**AGENDA
CITY OF CEDAR FALLS, IOWA
PLANNING AND ZONING COMMISSION MEETING
WEDNESDAY, AUGUST 28, 2019
5:30 PM AT CITY HALL**

TO: Planning and Zoning Commission
FROM: David Sturch, Planner III
DATE: August 21, 2019
SUBJECT: Land Use Map Amendment

TO: Planning and Zoning Commission
FROM: Iris Lehmann, AICP, Planner II
DATE: August 22, 2019
SUBJECT: Façade review of property in the Central Business District Overlay

TO: Planning & Zoning Commission
FROM: Iris Lehmann, ACIP, Planner II
Matt Tolan, Civil Engineer II
DATE: August 22, 2019
SUBJECT: Panther West Preliminary Plat

J:\5722.dwg Survey\Preliminary Plat\Preliminary Plat With Roundabout.dwg - Sheet 1 of 5 - 07-25-19 - 1:53pm - KMNS2

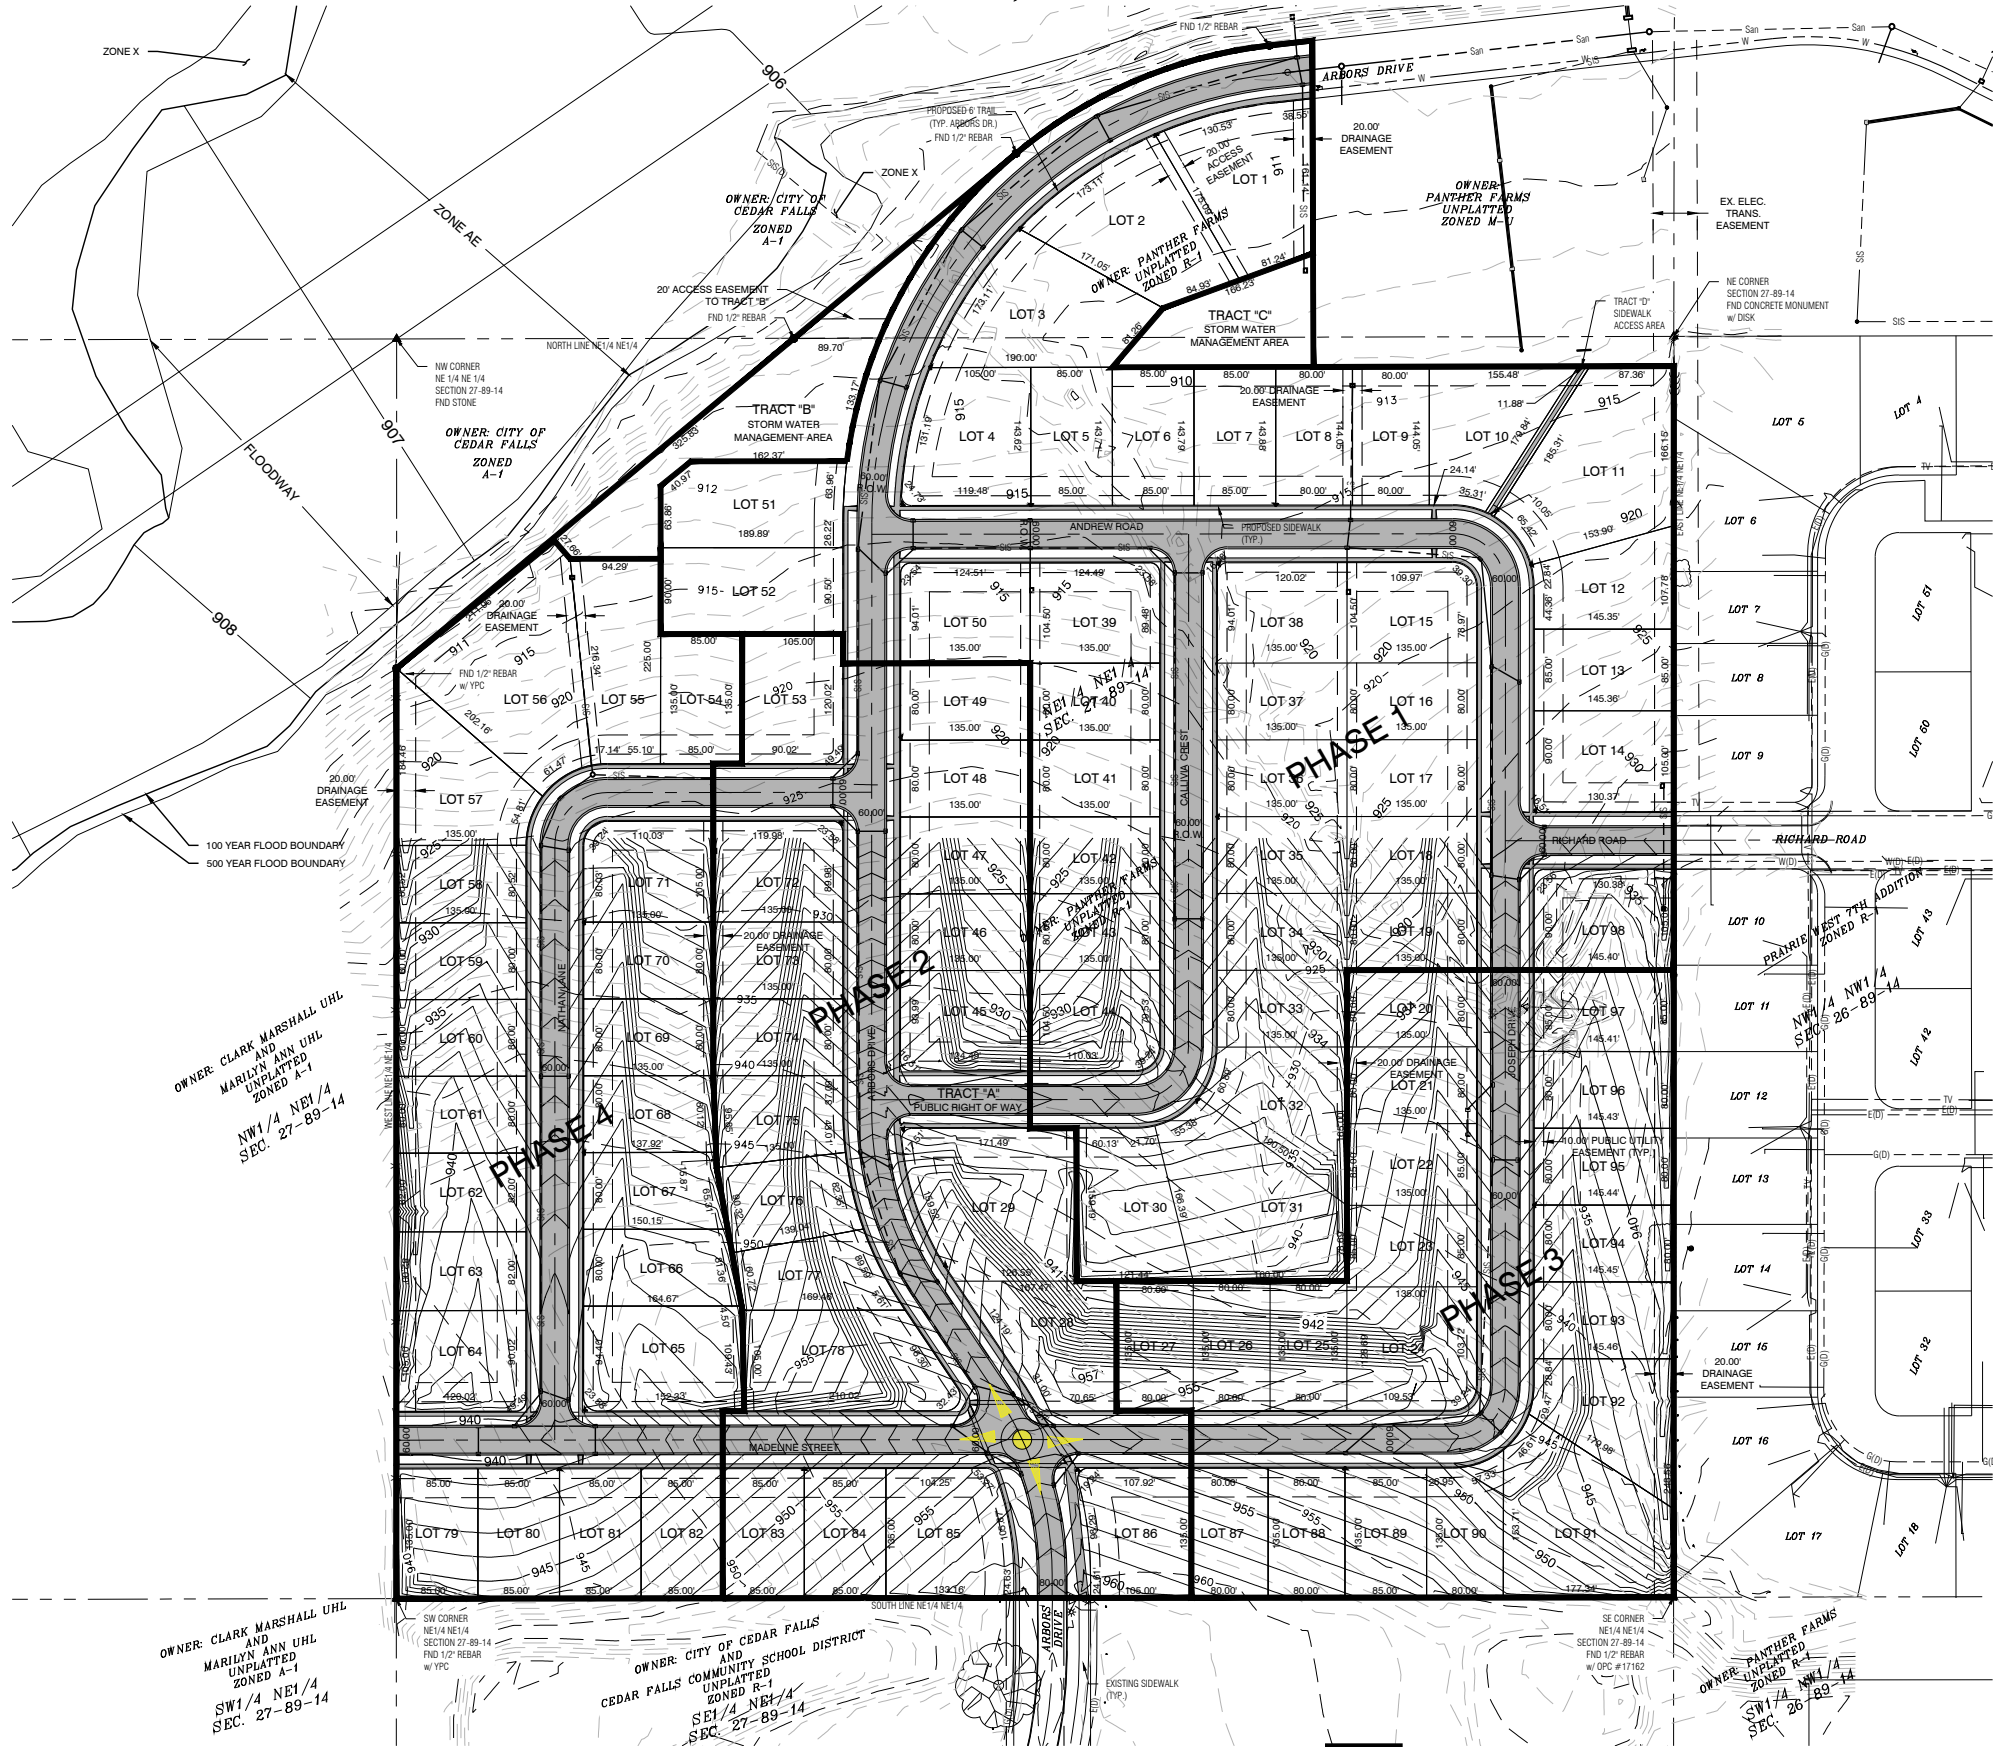
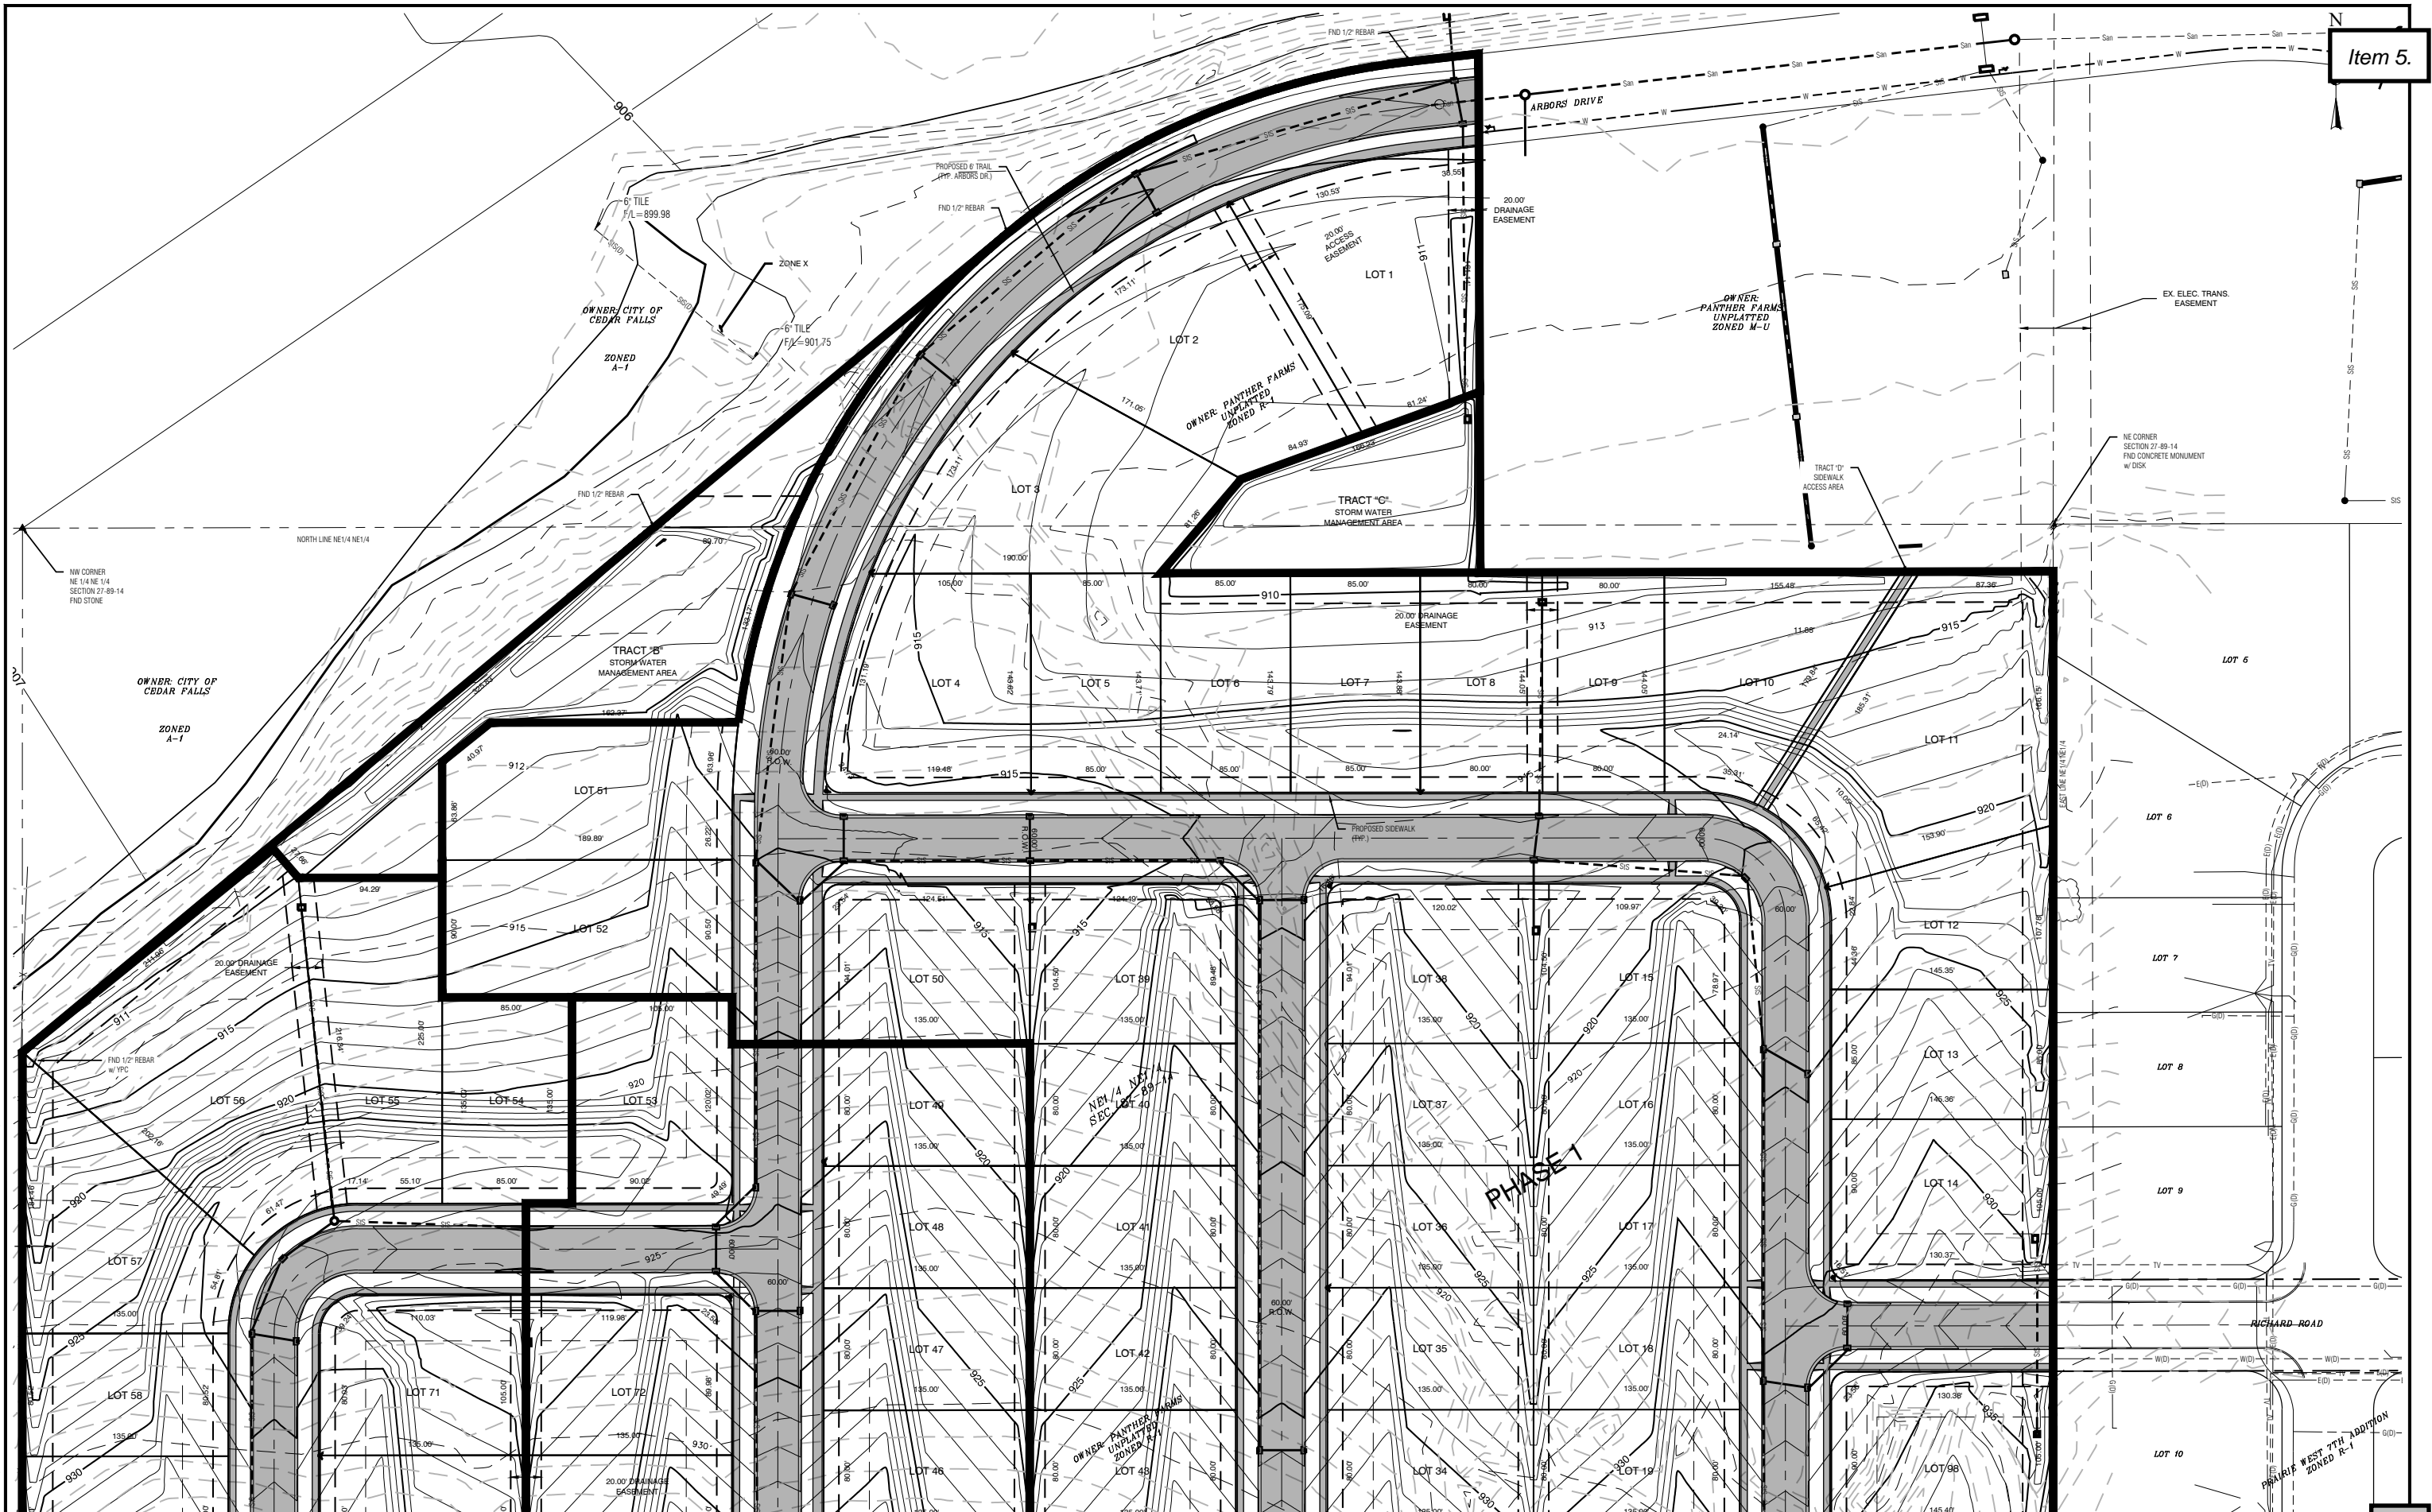
5. Add a drainage easement on the west side of lot 79.
6. Add a public access easement to Tract D and address responsibility for maintenance to the deed of dedication.

7. Add language at the end of item #18 of the Deed of Dedication to read as follows: "The location of the clustered mailboxes shall be approved by the City of Cedar Falls".

8. Change note #2 in the Deed of Dedication to "Contractor shall confirm the location of the cluster mailbox with the City of Cedar Falls prior to installation".

9. Show proposed locations of the cluster mailboxes on the preliminary plat.
10. Show the property owners within 200 feet of the plat.
11. Provide details on where the driveways will be placed on lots 86, 85, 78, 51, 48, 28, and 18. Staff has concerns with how these driveways may relate to the sidewalk crossings on these lots or the adjacent traffic circle.

The proposed Panther West Preliminary Plat is consistent with the development intent of this area and serves as an intermediate step in the development of this site. Staff recommends gathering any comments from the Planning and Zoning Commission and the public and then continuing the discussion of the proposed subdivision plat at the next Planning and Zoning Commission meeting on September 11, 2019. Approval will be subject to the resolution of the technical comments listed above.
